Addendum No. 3

ISSUED BY: Great River Engineering
2826 S. Ingram Mill Rd.
Springfield, Missouri 65804
(417) 886-7171

DATE: March 22, 2024

FOR: Shelbina Lake Bridge Replacement and Spillway Improvements
GRE Project # 4514

SPILLWAY REPAIR PLAN

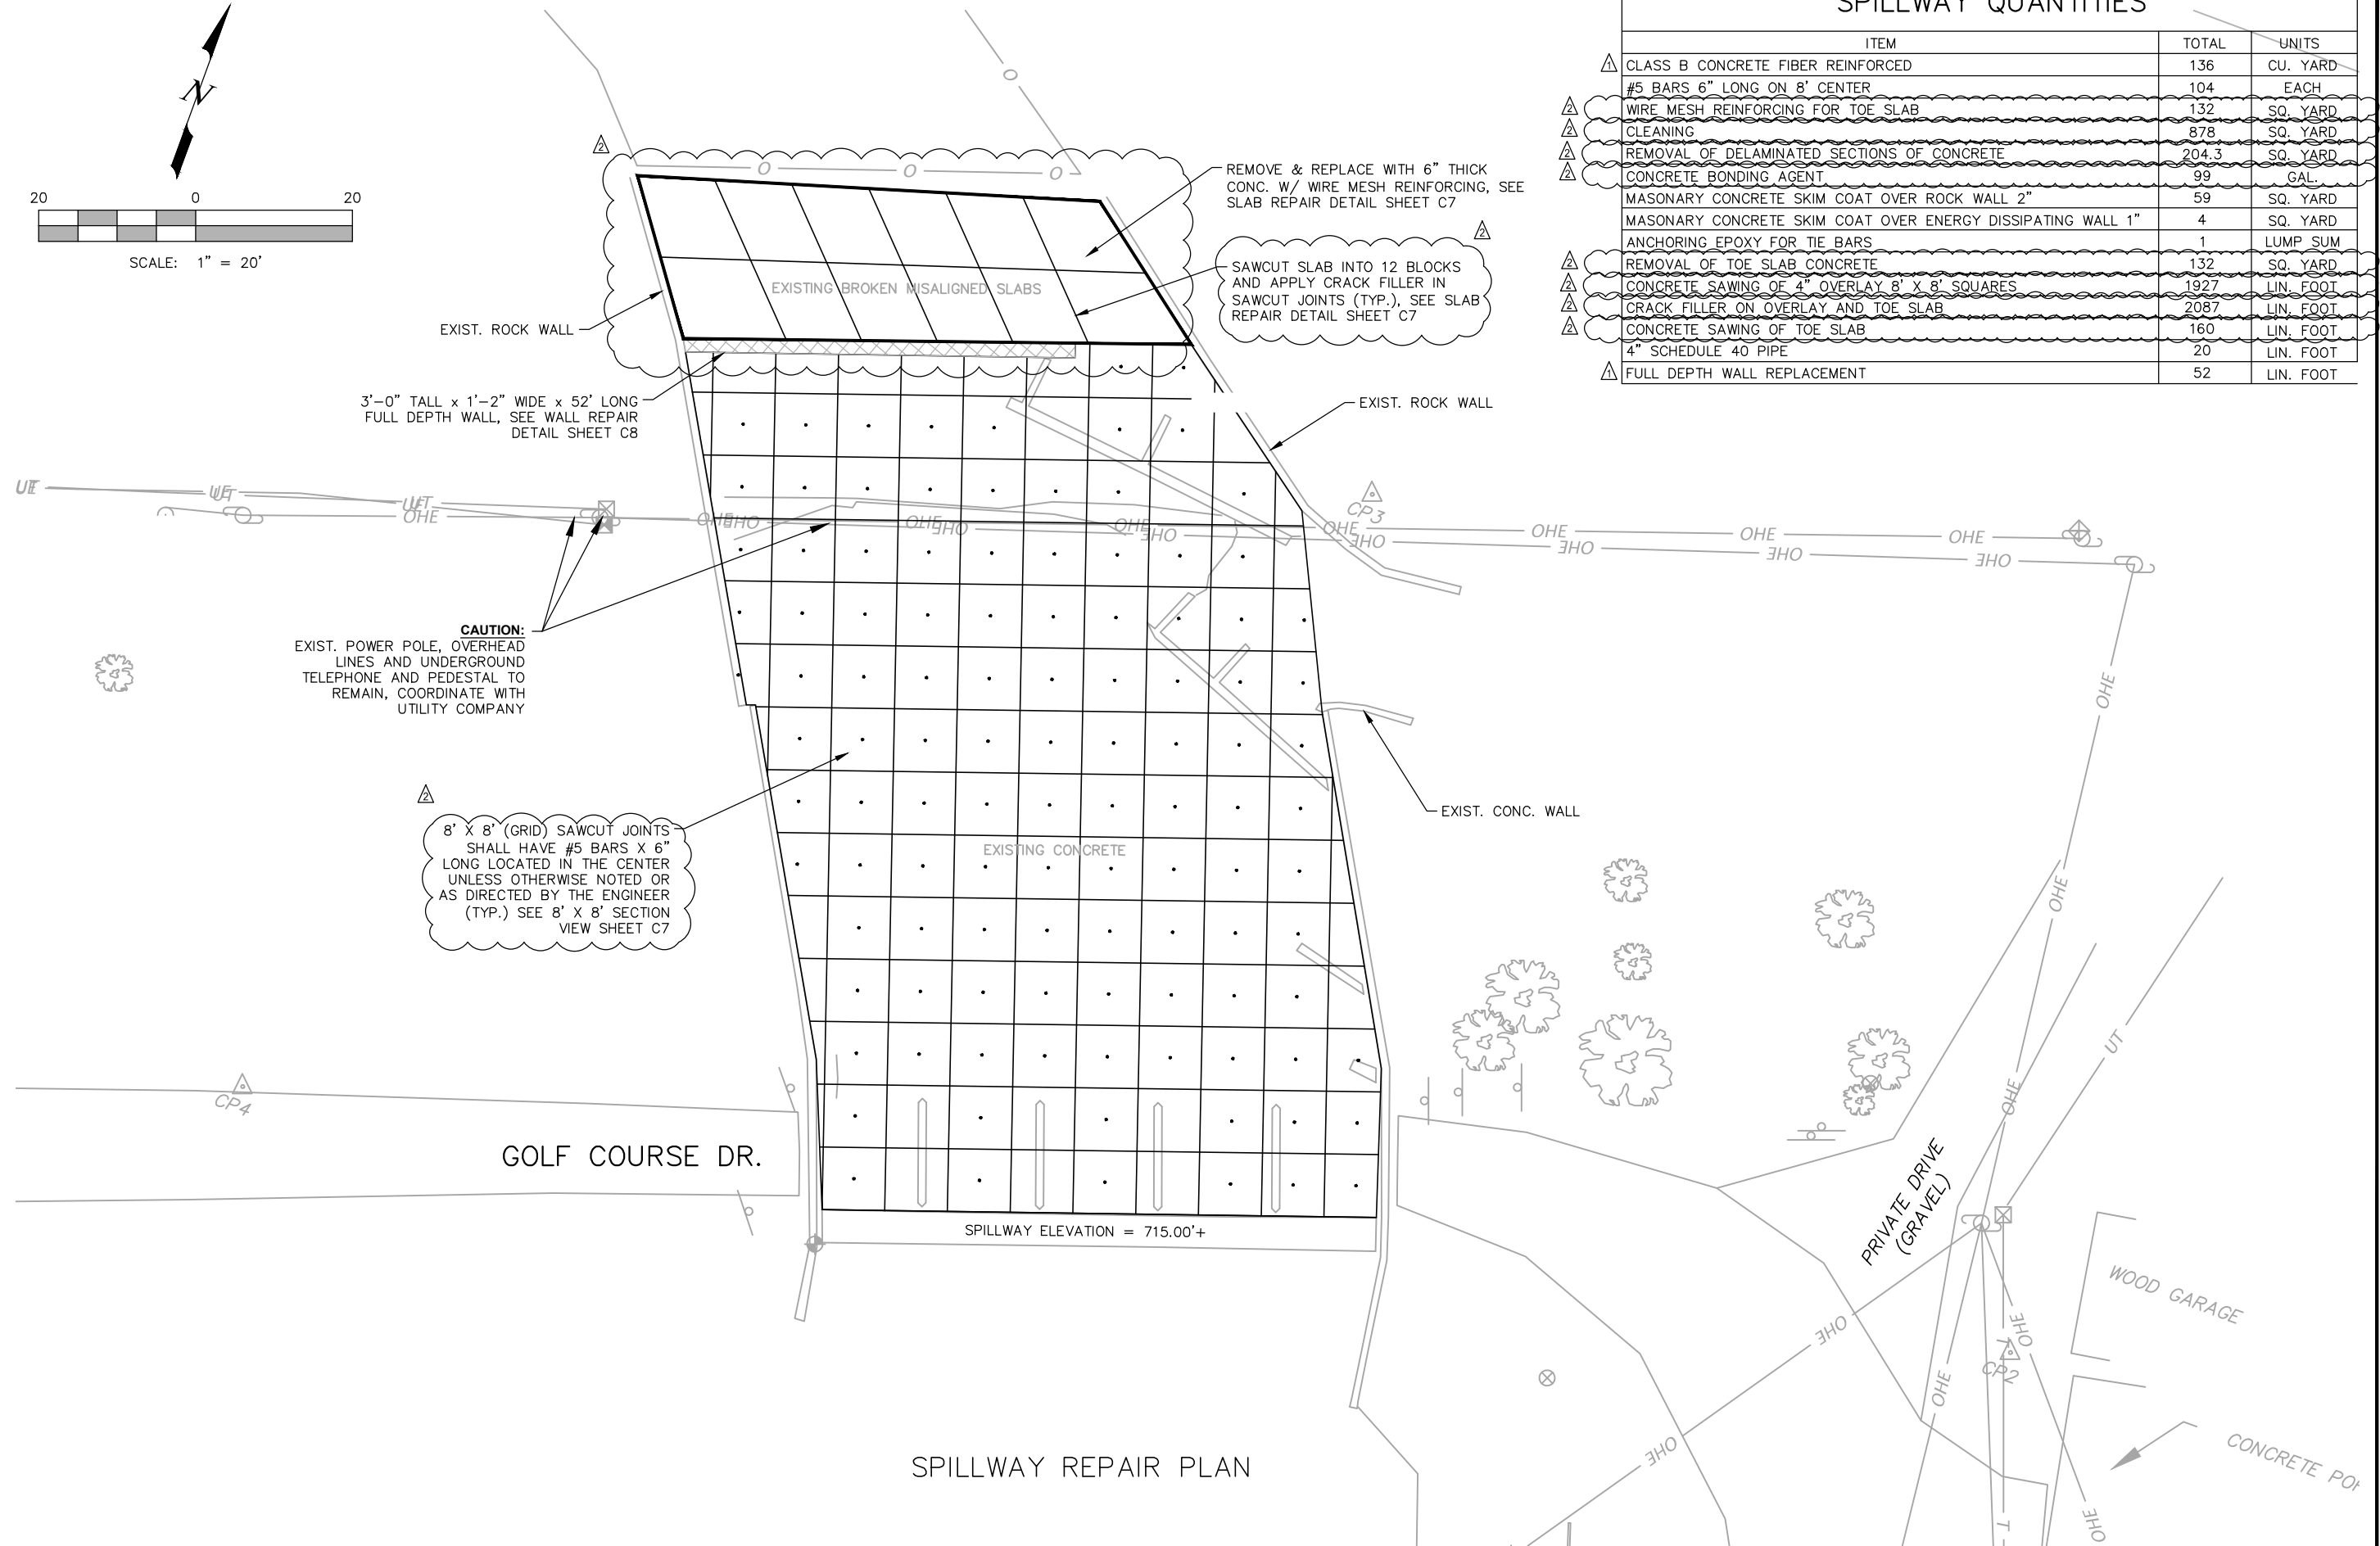
b. Sheet C6 Spillway Quantities were updated as follows:

- i. “#5 TIE BARS 30” LONG ON 30” CENTERS FOR SLAB REPLACEMENT” was removed and replaced with 132 SY of “WIRE MESH REINFORCING FOR TOE SLAB”.
- ii. The quantity for “CLEANING” was updated to be 878 SY.
- iii. The quantity for “REMOVAL OF DELAMINATED SECTIONS OF CONCRETE” was updated to be 204.3 SY.
- iv. The quantity for “CONCRETE BONDING AGENT” was updated to be 99 GAL.
- v. The line item “REMOVAL OF SLAB CONCRETE” was renamed to “REMOVAL OF TOE SLAB CONCRETE” to provide clarification of where the location for removal was on the plans.
- vi. The quantity for “REMOVAL OF TOE SLAB CONCRETE” was updated to 132 SY.
- vii. The quantity for “CONCRETE SAWING OF 4” OVERLAY 8’ X 8’ SQUARES” was updated to be 1927 LF.
- viii. The line item for “CRACK FILLER ON OVERLAY AND SLAB” was renamed to “CRACK FILLER ON OVERLAY AND TOE SLAB” to provide clarification on the location for crack filler.

- ix. The quantity for “CRACK FILLER ON OVERLAY AND TOE SLAB” was updated to 2087 LF.
- x. The line item “CONCRETE SAWING OF SLAB” was renamed to be “CONCRETE SAWING OF TOE SLAB” to provide clarification of the location of the referenced slab.

- c. Sheet C6 “SPILLWAY REPAIR PLAN” was updated to include the sawcut lines for the full depth repair toe slab and a note regarding sawcuts. It was also updated to include that the placement of the #5 Bars X 6” location is to be in the center unless otherwise noted or as directed by the engineer.

8' X 8' (GRID) SAWCUT JOINTS SHALL HAVE #5 BARS X 6" LONG LOCATED IN THE CENTER UNLESS OTHERWISE NOTED OR AS DIRECTED BY THE ENGINEER (TYP.) SEE 8' X 8' SECTION VIEW SHEET C7

GOLF COURSE DR. BRIDGE #39650021
 CITY OF SHELBYNA, MISSOURI
 SPILLWAY CONSTRUCTION DETAILS

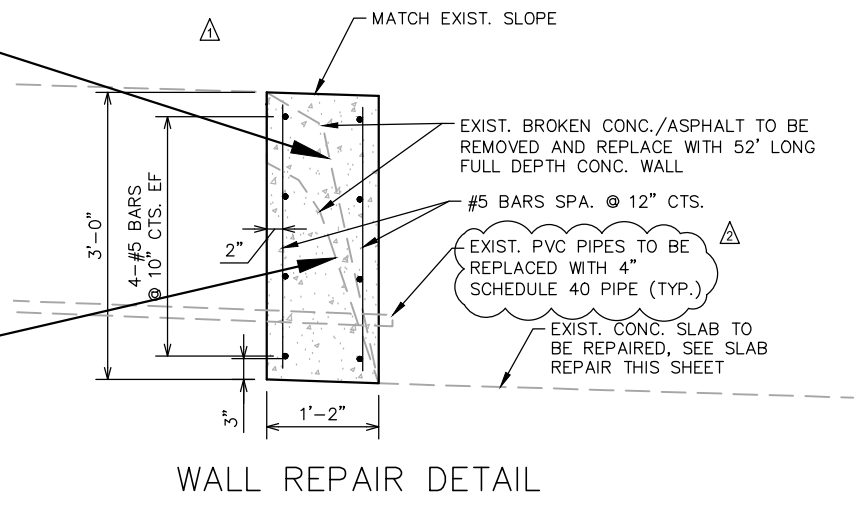
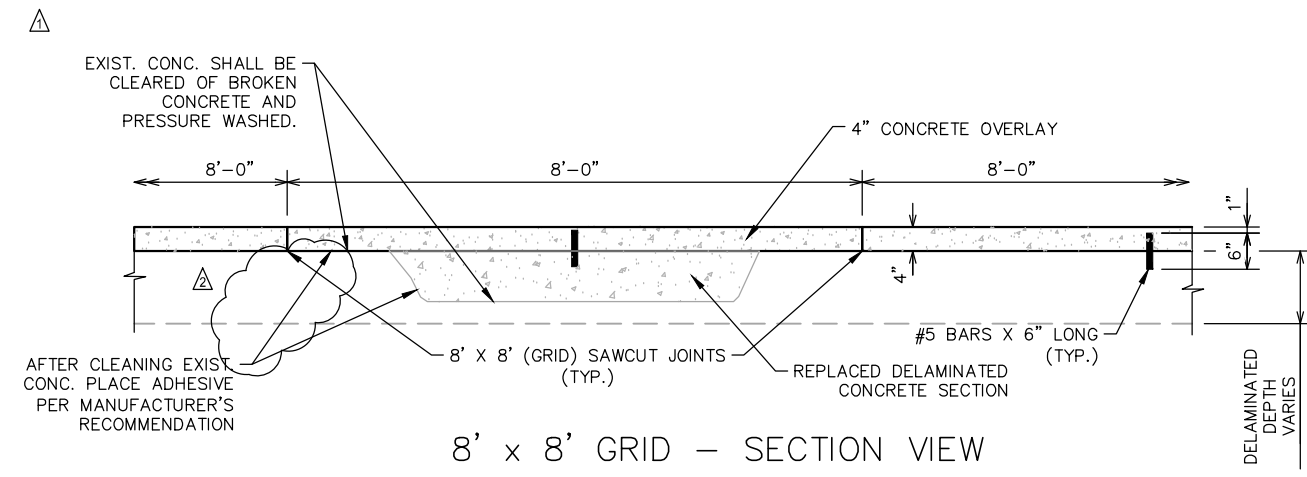
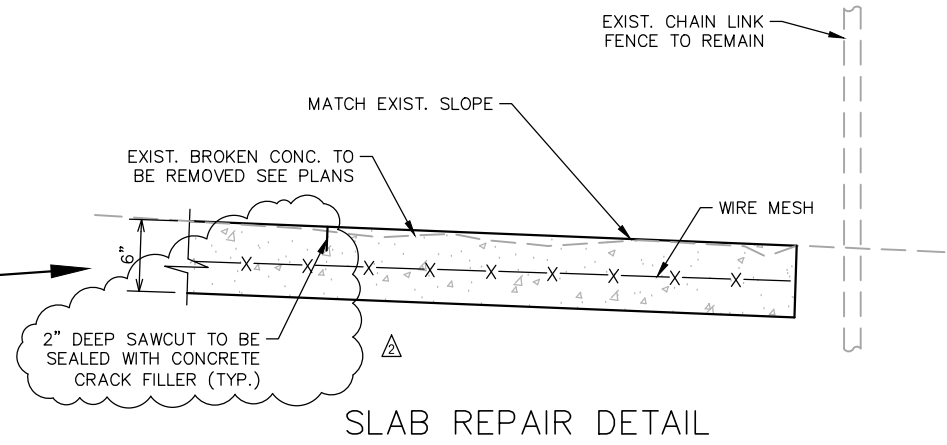
- d. Sheet C7 “SLAB REPAIR DETAIL” was updated to show depth and location of sawcuts for the full depth repair toe slab.
- e. Sheet C7 “8’ X 8’ GRID – SECTION VIEW” was updated to include an extra arrow to clarify the placement of adhesive prior to placement of the 4” overlay.

- f. Sheet C7 “WALL REPAIR DETAIL” was updated to clarify that the existing ends of the PVC pipes located in the wall would be removed during destruction of the wall and need to be replaced with 4” Schedule 40 Pipe.
